SERVICE BULLETIN

1/2" and 3/4" Diaphragm Pump Changes PX05X-XXX-XXX-B, PX07X-XXX-XXX, 6700XX

#2-08

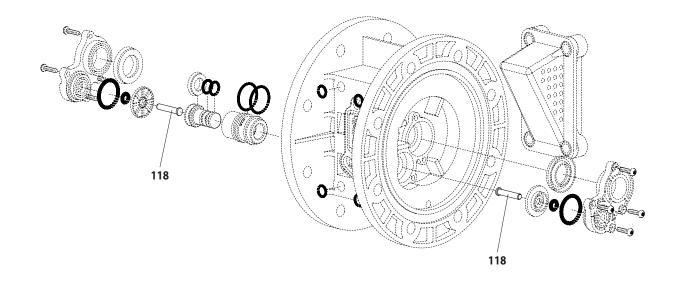
1. Item "118" actuator pin (pn 94874-1, 1.047" long) replaced with (pn 97111, 0.885" long).

This change is effective on models built after September 30, 2008 (serial number I0308XXX).
